Interactive comment on “Development and evaluation of a building energy model integrated in the TEB scheme” by B. Bueno et al.

REVIEWER #1

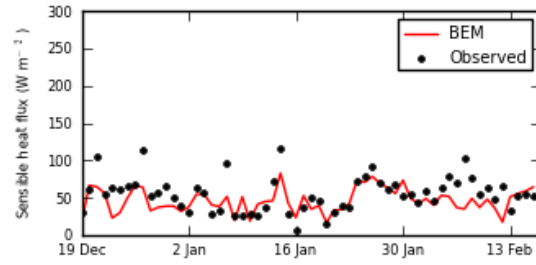
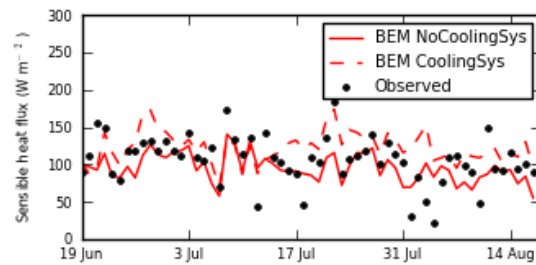
Comment 2.5. Page 2975 Line 25: The authors claim that the coupled scheme (CS) did not allow for coupling with atmospheric model and therefore they develop a new version of TEB integrating a new building energy model. However, they did not show in the evaluation section the effect of this strategy on the surface turbulent flux calculated by TEB which are passed to the lowest atmospheric level for the next time step.

A comparison of surface heat fluxes will be included.

We will compare the sensible heat fluxes observed during the experiment CAPITOUL with those calculated by BEM-TEB (see attached figures). Two scenarios will be considered. In the first one, we assume no waste heat emissions associated with cooling systems. This represents a situation in which air-conditioning systems are not widely used. In the second scenario, all buildings of the urban area under study are assumed to have conditioned spaces and waste heat emissions from cooling equipment are re-released into the environment. The comparison shows a good agreement with an RMSE = 26.7 W m⁻² between the daily-average sensible heat fluxes calculated by BEM_TEB and from observations for a whole-year simulation. The average difference in sensible heat flux with and without waste heat emissions is 27 W m⁻² in summer.
